Access Compliance Report

Public Rights-of-Way

(Curb Ramps)

Intersection ID: 10031127	Main Street: MARGARET_WALLACE_RD	Cross Street: N/A	Location: NW
ADA ID: 0997C3C10855	Ramp Type: PerpDiag	Initial Pass/Fail: Fail	Overall Compliance: No
Severity Score: 47.5			
Codes/Mitigation Info/Possible Solution		Field Measurements/Component Compliance

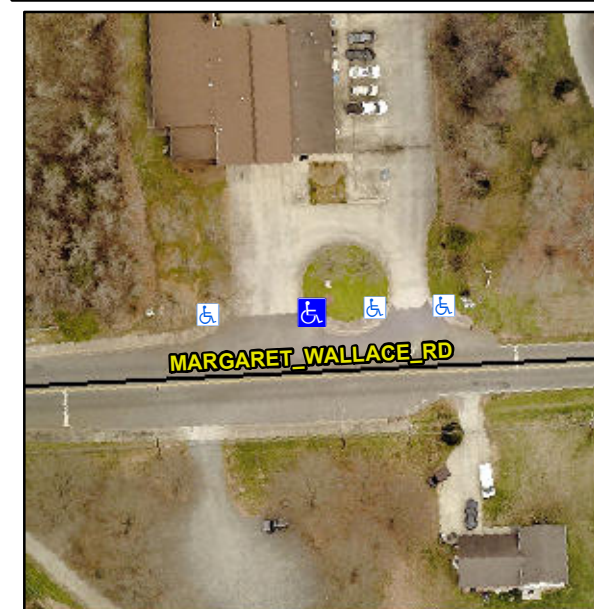
Not Found, R304.5.1, R304.2.2

Compliance	Description	Data	Compliance	Description	Data
N/A	Ramp Length (in)	58.5	No	Ramp Slope (%)	8.7
No	Ramp Width (in)	24.0	Yes	Ramp XSlope (%)	0.1
N/A	Flare Type LT	N/A	N/A	Flare Type RT	N/A
N/A	Flare Slope LT (%)	N/A	N/A	Flare Slope RT (%)	N/A
N/A	Flare Traversable LT?	N/A	N/A	Flare Traversable RT?	N/A
N/A	Landing Length (in)	N/A	N/A	DWS Provided?	N/A
N/A	Landing Width (in)	N/A	N/A	DWS Contrast?	N/A
N/A	Landing Slope (%)	N/A	N/A	DWS Length (in)	N/A
N/A	Landing X Slope (%)	N/A	N/A	DWS Full Width?	N/A
N/A	Landing Curb? (Y/N)	N/A	N/A	DWS Offset (in)	N/A
N/A	Shared Landing?	N/A			
N/A	Gutter Ponding?	N/A	N/A	Gutter Slope (%)	N/A
N/A	Gutter Lip Ht (in)	N/A	N/A	Gutter X Slope (%)	N/A
N/A	Painted X Walk1?	No	N/A	Painted X Walk2?	No
	X Walk 1 Direction	To E		X Walk 2 Direction	To S
N/A	X Walk 1 Width (in)	N/A	N/A	X Walk 2 Width (in)	N/A
	X Walk 1 Slope (%)	0.2		X Walk 2 Slope (%)	0.5
	X Walk 1 X Slope (%)	2.4		X Walk 2 X Slope (%)	1.9

Remove & Replace Curb Ramp With Two New Directional Ramps or Equivalent.
